Body Repair News

MODEL/YEAR MODÈLE /ANNÉE	DATE OF ISSUE DATE EN VIGUEUR	BULLETIN NUMBER NUMÉRO DU BULLETIN
ALL MODELS	July 8, 2014	BRN-14-4
Rev. January 4, 2018: Revisions, new information

Body Repair Manual Welding & Sectioning Guideline Revisions

Rear Inner Panel Service Part Example

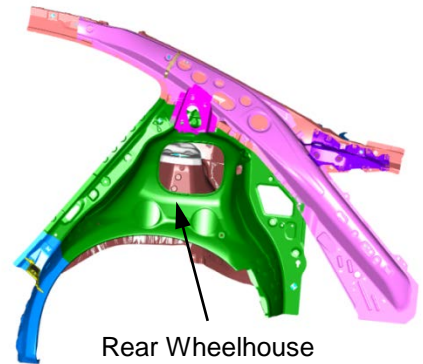
- Replacement of body service parts as supplied at factory seams is the preferred repair method, except when it may cause unnecessary or excessive intrusion into the body structure.
- In these cases, the service part may be disassembled at factory seams as required to replace only the damaged portion.
- For example, if only the vehicle's rear wheelhouse is damaged, that part may be removed from the rear inner panel service part assembly at the factory seams and installed on the vehicle.
- Note that there is **not** a BRM replacement procedure for rear inner panels because they are rarely installed as a complete unit.
- All basic welding & sectioning guidelines specified in the service information **must** be observed during partial panel replacement.

Sectioning Area Examples

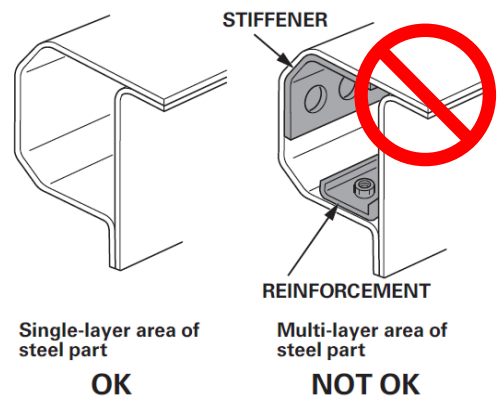
- Outer body and floor panels may be sectioned as necessary. Specific sectioning procedures are not provided in the BRM.
- Depending on the type of vehicle damage, steel parts with a tensile strength of 780 MPa or less may be sectioned **if all three of the following conditions are met:**

1. Sectioning must be done in a single-layer area of the part.
 2. Multi-layer internal steel reinforcements and stiffeners must not be cut.
 3. Do not section in load bearing areas, such as engine, transmission, or suspension mounting points.
